# Pandora Sweaters Ltd.

Gilar Chala, Master Bari, Shreepur, Gazipur.  
(24.187444, 90.424696)  
19<sup>th</sup> April 2014

# Observations

# Cracking in Beams in 6-Storey Building, Third Floor

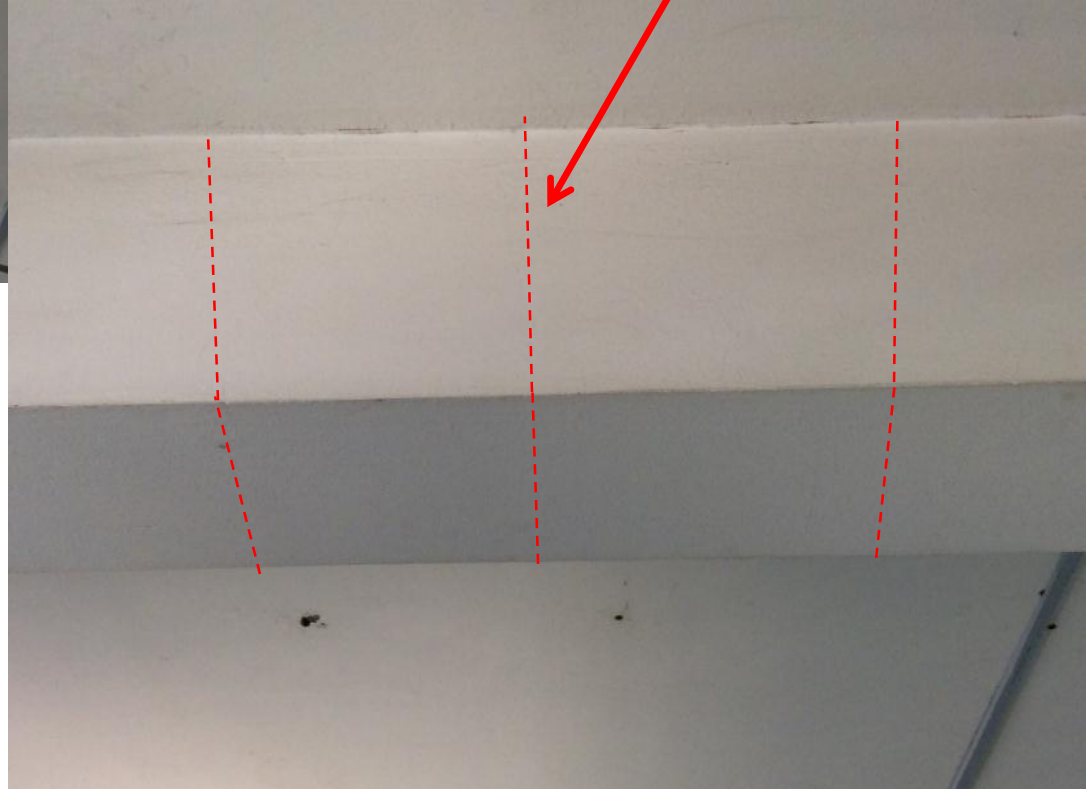
Hairline cracks to the beams at mid-span occur on the 3<sup>rd</sup> Floor of the 6-storey building.

Building engineer to confirm cracks are typical of normal structural behaviour, and to ensure the load on the 4<sup>th</sup> floor does not increase.

# **Modified truss configurations in Boiler/Generator Building need investigation**

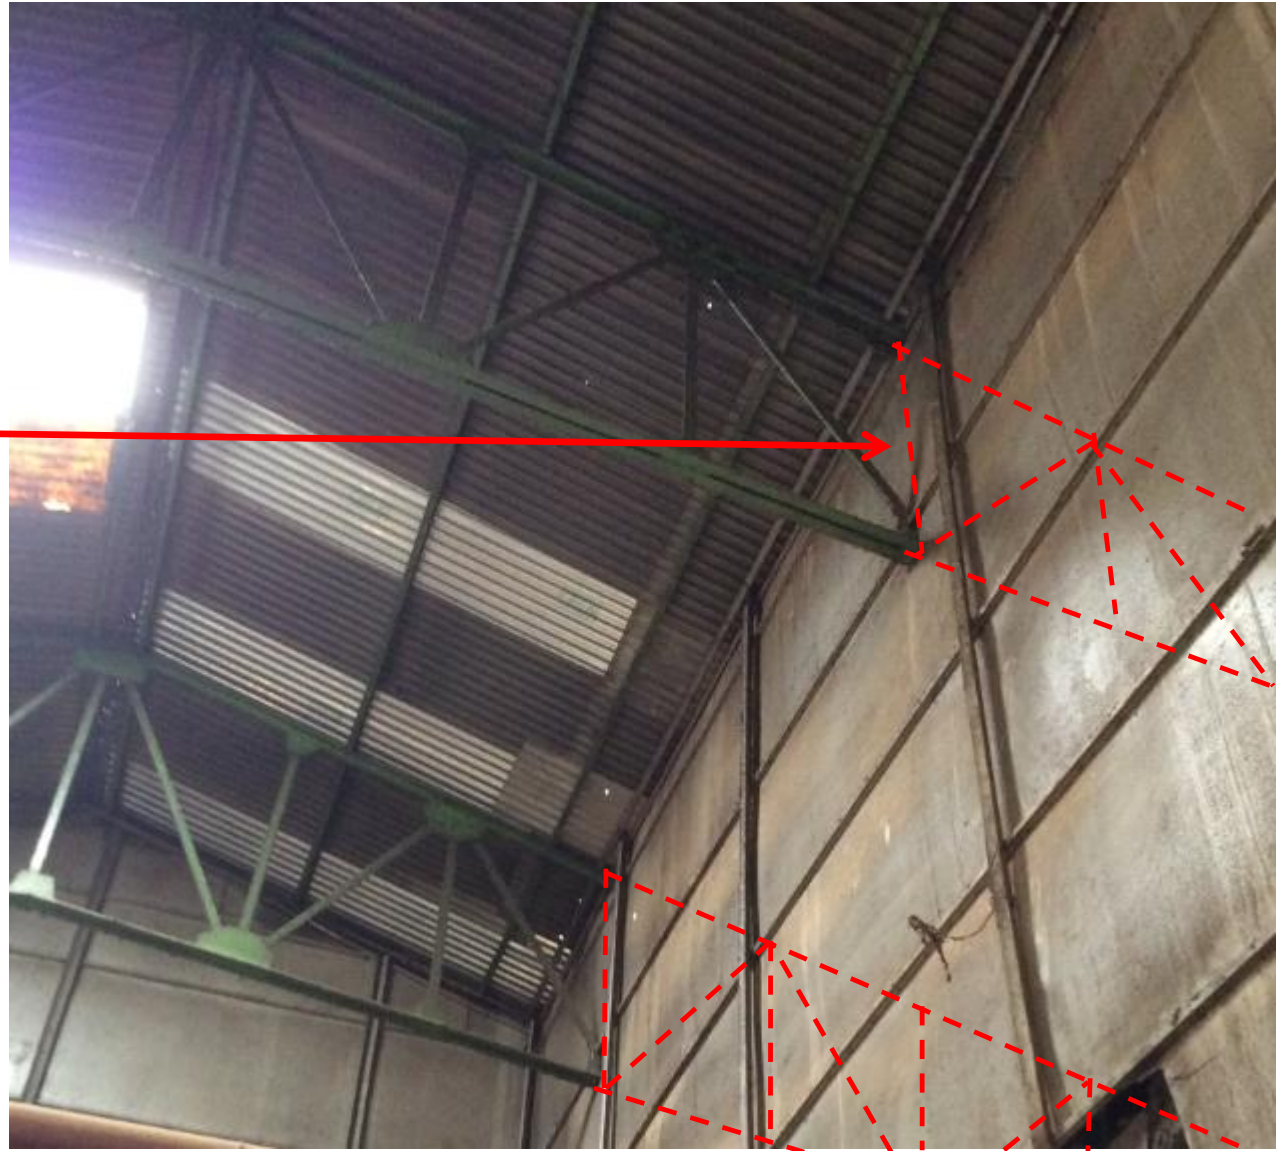
**New 6 Storey building impinged on existing boiler and generator building.**

**Part of the existing steel truss has been cut to allow for the new building (see also next slide).**

Part of the existing steel truss has been cut to allow for the new production building. New connection into brickwork wall and vertical tie in truss missing at the support.

Building Engineer to investigate adequacy of truss support at wall

# Steel canopy at entrance of ad-hoc construction

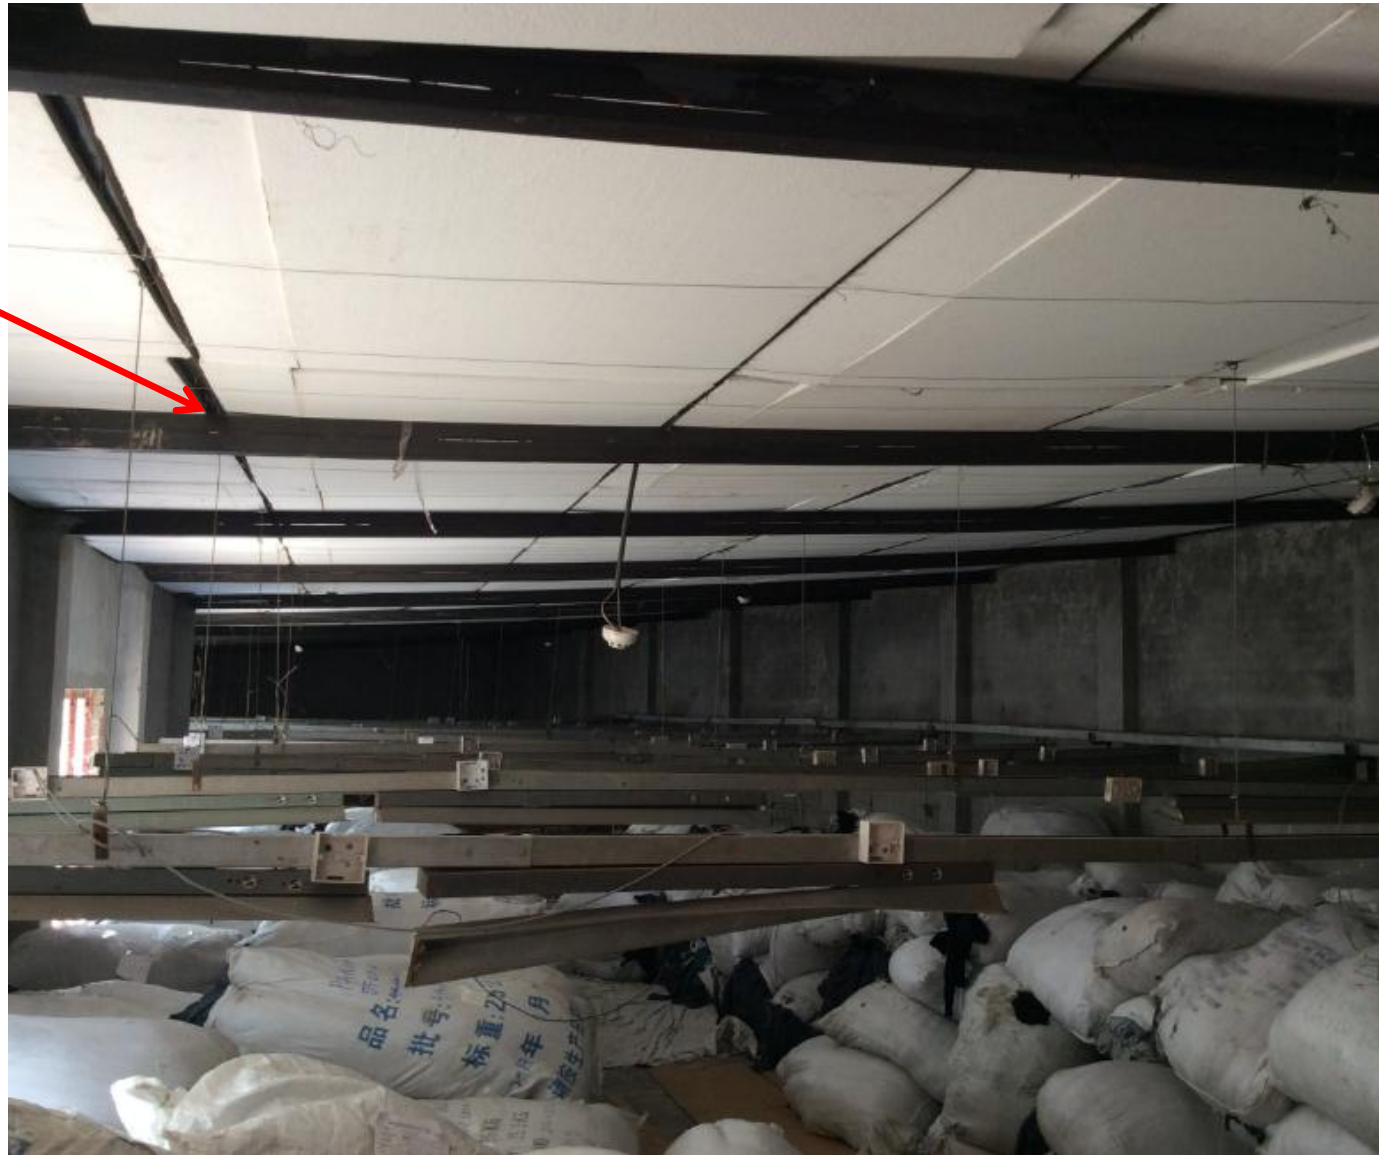
**Steel canopy  
entrance of ad-hoc  
construction with  
substantial  
deflection.**

**Purlins appear  
inadequate to  
support 7.0m span.  
Building Engineer to  
recommend new  
canopy structure.**
